DFE normalization in TDECQ penalty computation

Laurent Alloin, Eric Maniloff, Amitkumar Mahadevan
Ciena

Summary

Example of impact of a reflection

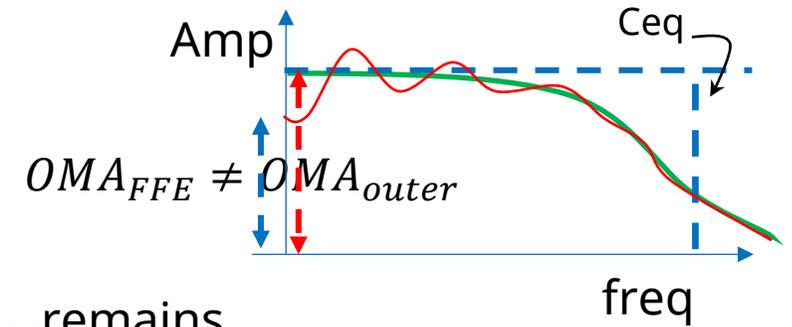
In case of a destructive reflection $OMA_{FFE} < OMA_{outer}$, as OMA_{outer} measured per SC 180.9.5 is equivalent to the OMA of a transmitter without the impact of the reflection.

However, the magnitude of B is proportional to OMA_{FFE} , while OMA_{outer} remains independent of the impact of the reflection.

By normalizing b to OMA_{outer} in draft 2.2, as in $b = B/(OMA_{outer}/2)$ we now report a normalized DFE tap b, which varies with the impact of the reflection.

The normalized DFE tap b appears different for modules of same bandwidth but with different reflections

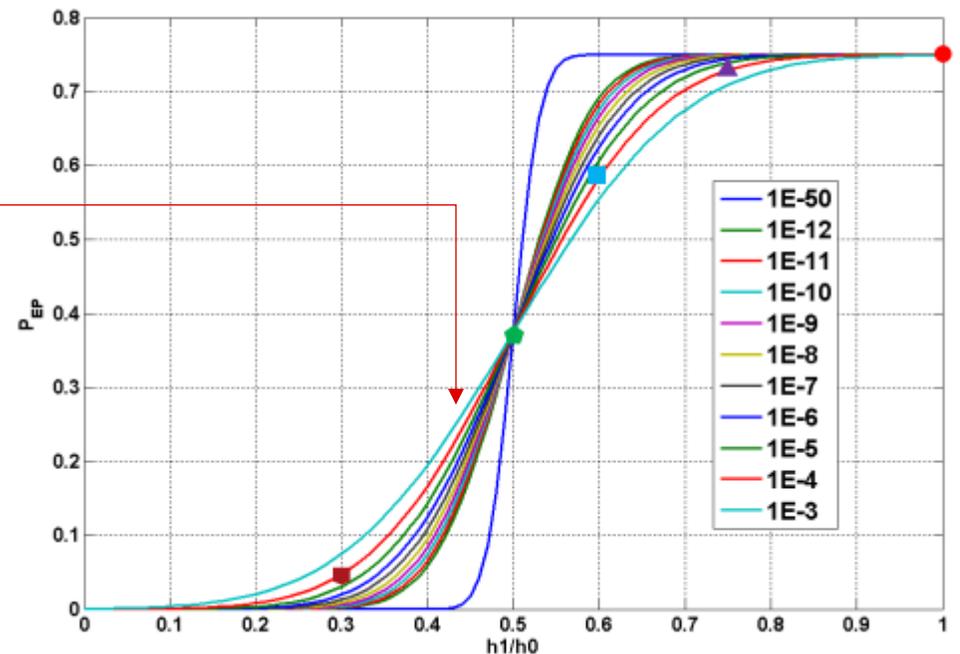
While we may think $b_{max} = 0.3$, leads to a probably of error propagation $P_{EP} \ll 0.1$, normalizing b to $OMA_{Outer}/2$ effectively leads to an equivalent $b_{max} = 0.4286 \sim 0.43$ with $P_{EP} \gg 0.2$ in the 1-tap DFE error propagation model

Follows the relationship : $(OMA_{FFE} / OMA_{SLICER}) = b / (1-b)$ when b is normalized to $OMA_{FFE} / 2$

=> b_{max} value of 0.3 may still be acceptable, but is effectively 0.43 in the error propagation model !

$$b_{max} = 0.43 = 0.3/(1-0.3)$$

Pre-post equalizer coefficient difference limit

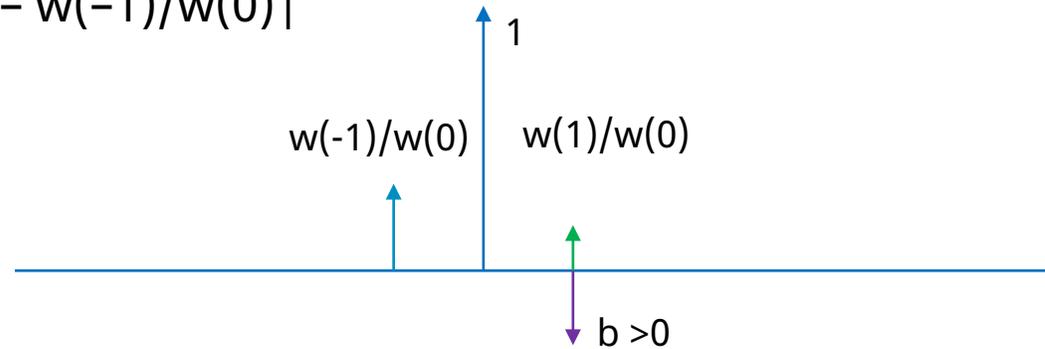
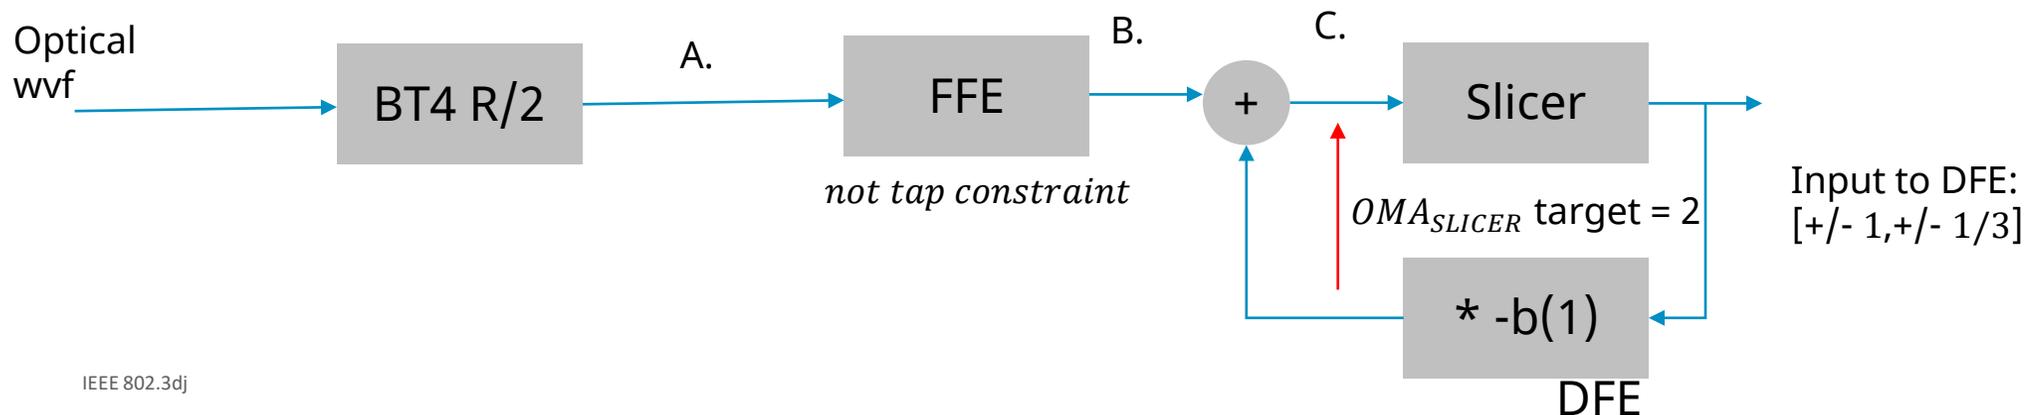
The pre-post equalizer coefficient difference limit equation was amended to reflect the addition of the DFE in draft 2.2 to $|w(1)/w(0) - b(1) - w(-1)/w(0)|$

where $w(i)$ are the FFE coefficients and $b(1)$ is the normalized DFE tap wrt. $OMA_{outer}/2$

However, for this equation to be correct, the DFE tap should be normalized wrt. $OMA_{SLICER}/2$, as in the following model:

the limit eq should become: $|w(1)/w(0) - (b(1)/(1-b(1))) - w(-1)/w(0)|$

Results of pre-post coeff limit implementation

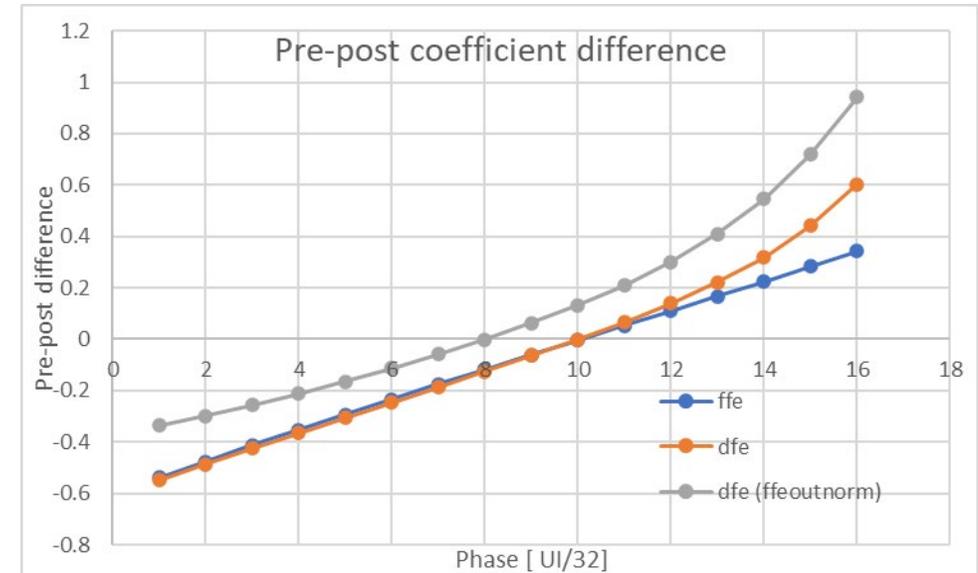
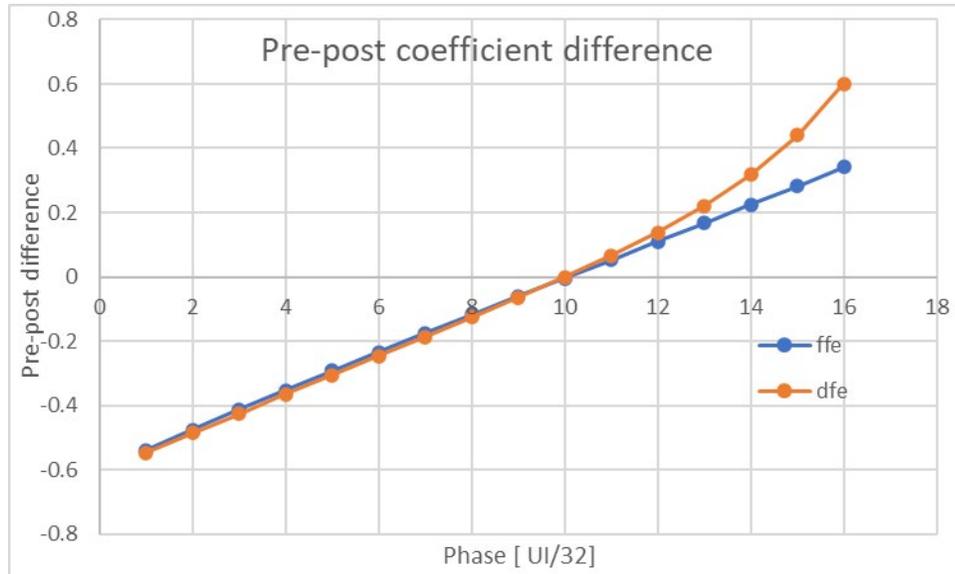
When implemented with the proper DFE normalization, the pre-post equalizer coefficient limit equation tracks the delay of the signal sampled with a varying phase offset

FFE and DFE difference equations align

FFE and DFE difference equations deviate !

Results of pre-post coeff limit implementation

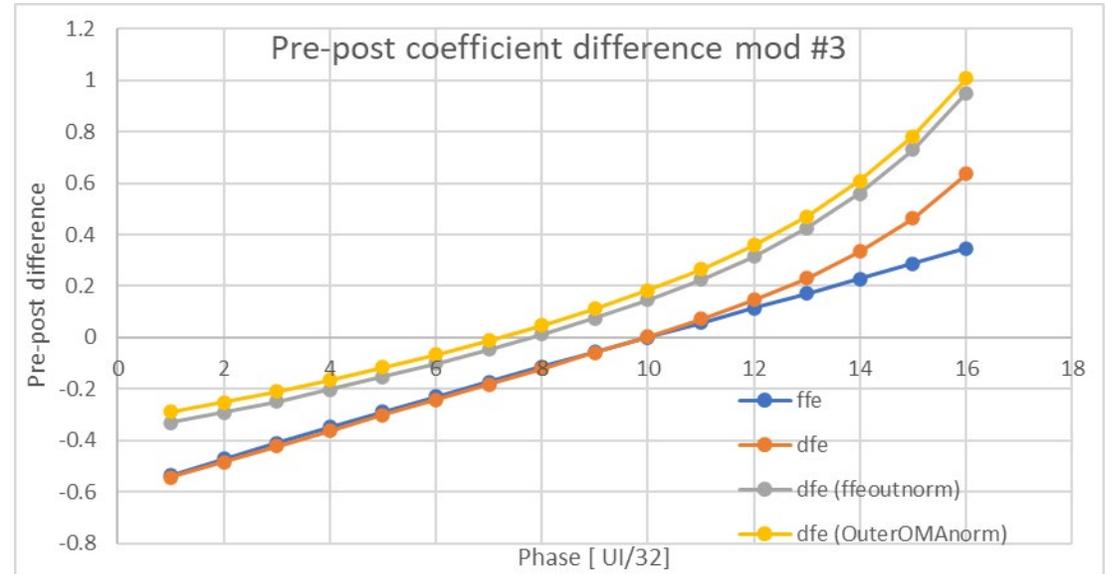
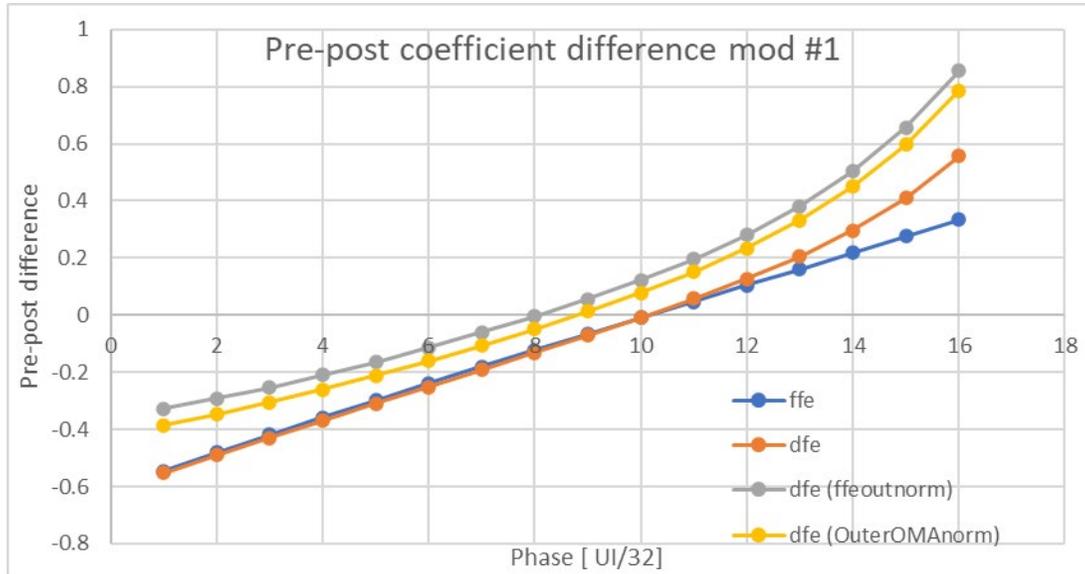
When implemented with the proper DFE normalization, the pre-post equalizer coefficient limit equation tracks the delay of the signal sampled with a varying phase offset

FFE and DFE difference equations deviate !

Plus, it is now impacted by different reflections across modules !
